Re: W.P. 274-60 Huntley Twp. C.N.R. O'Head  
W.P. 275-60 Carp R. Bridge Hwy. 44  
District #9.

PROPOSED NEW CROSSING OF  
HWY. 44 AND CARP RIVER AND C.N.R.

FOUNDATION INVESTIGATION REPORT

PROPOSED CROSSING  
HIGHWAY 44 AND CANADIAN NATIONAL RAILWAY  
TOWNSHIP OF HUNTLEY, DISTRICT NO. 9  
WP 274-60

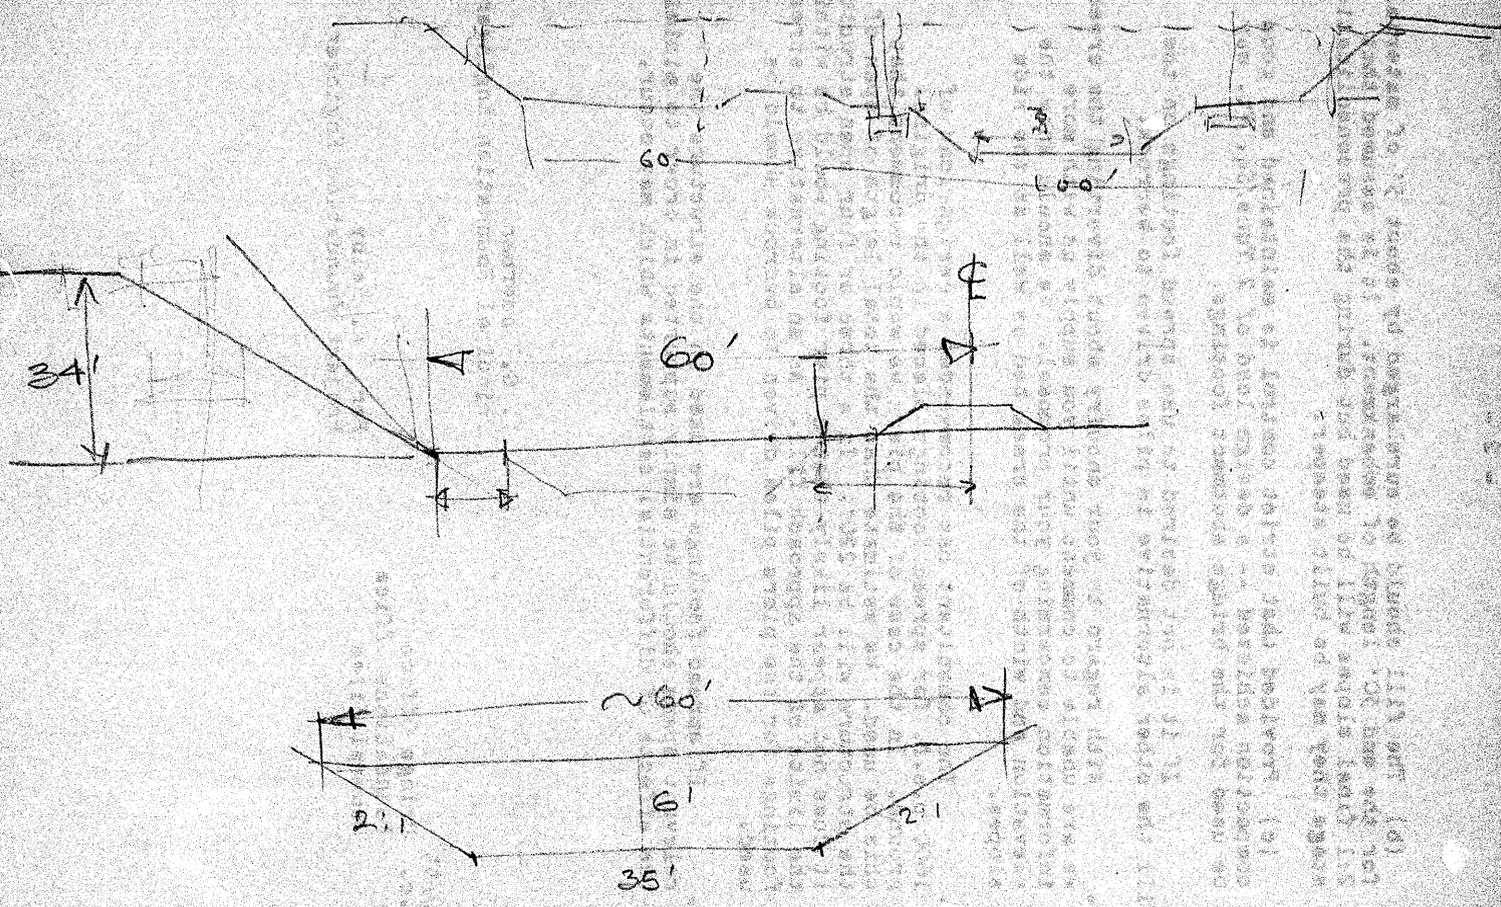
1. The distance from the toe of the approach fill to the  $\frac{1}{2}$  of the railway should be not less than 60'. According to our calculations based upon the Westerguard Equations the increase in pressure under the railway due to the influence of the 34' high embankment will be less than the existing preconsolidation pressure values of the subsoil. In consequence settlements under the railway should be negligible if the above-mentioned distance is maintained.
2. We would not recommend that the abutments be supported by spread footings in original ground owing to the low recommended safe bearing pressure of 1600 lbs/sq. ft., and the fact that the footings in such a case would also have to support the full height of the 34.0' fill at completion of construction.

We do recommend that the abutments be supported by spread footings in the fill provided that the following conditions are observed:-

(a) The fill should be placed about 12 months prior to the bridge construction and compacted for the full width of the embankment under conditions of strict control; a granular material should preferably be used as it is easier to control.

(b) The fill should be surcharged by about 5' of material for the end 50' length of embankment. It is assumed that 2:1 final slopes will be used but during the preconsolidation stage they may be built steeper.

(c) Provided that strict control is maintained and good compaction achieved -- a design load of 2 Tons/Sq. Ft. may be used for the bridge abutment footings.

If it is not desired to use spread footings on the fill the other alternative is piles driven to bedrock.

W.P. 274-60  
W.P. 275-60

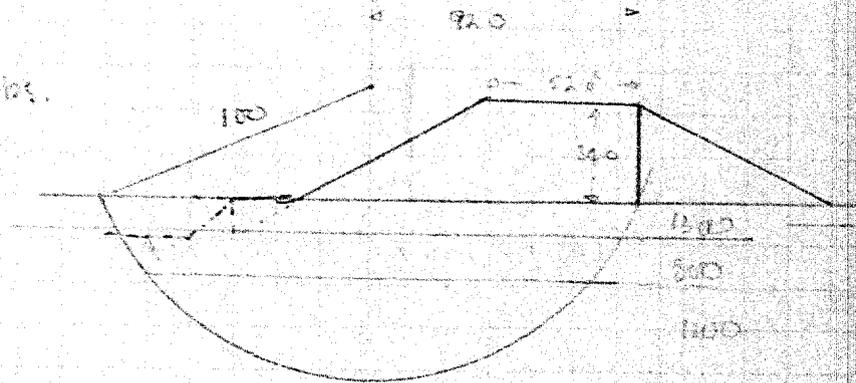
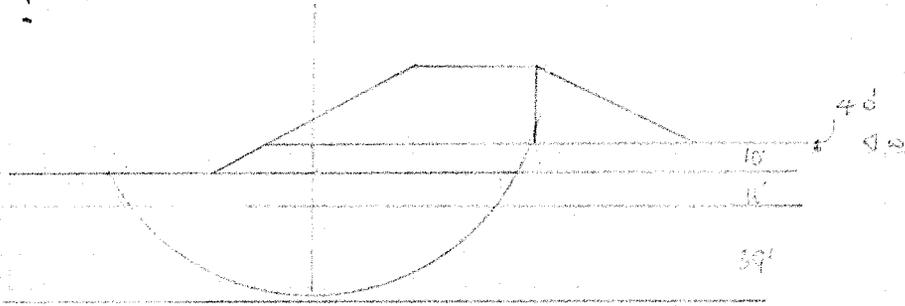
Activating moments

$$130 [(52.0 \times 24.0 \times 66) + (\frac{14+34}{2} \cdot 40 \cdot 23)]$$

$$= 18,100,000 \text{ ft. lbs.}$$

Resulting moment:

$$= 25,250,000 \text{ ft. lbs.}$$

FS:  $\frac{25,250,000}{18,100,000}$

1.4

If embankment has C=800 FS = 1.50

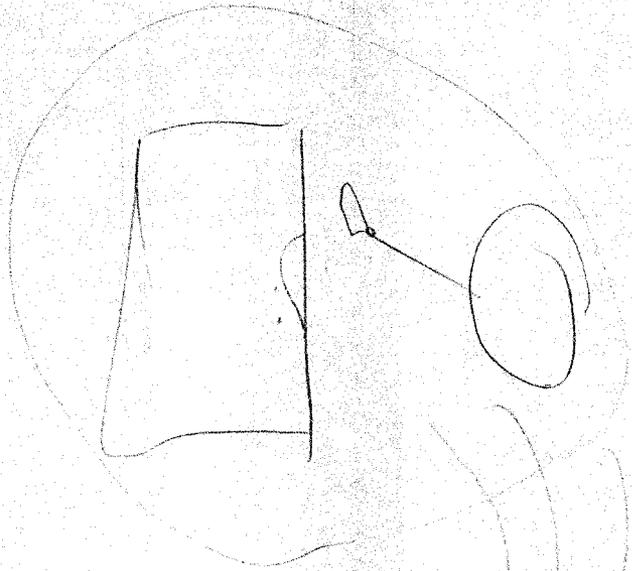
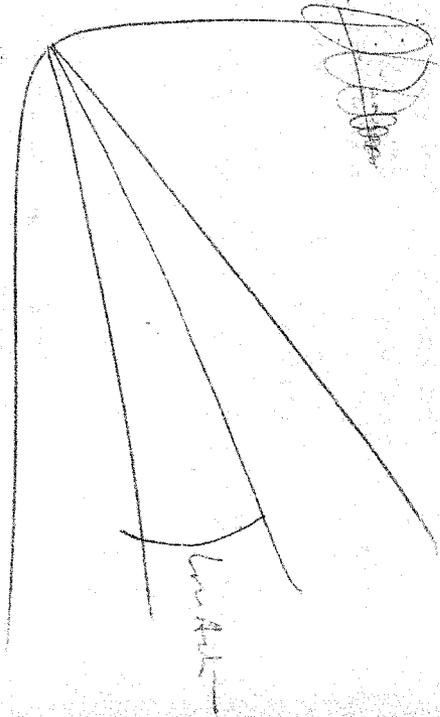
Actuating Moments

$$= 21,705,000$$

Resisting Mom

$$\underline{\underline{24,203,500}}$$

$$FS = \frac{24,203,500}{21,705,000} = 1.12$$
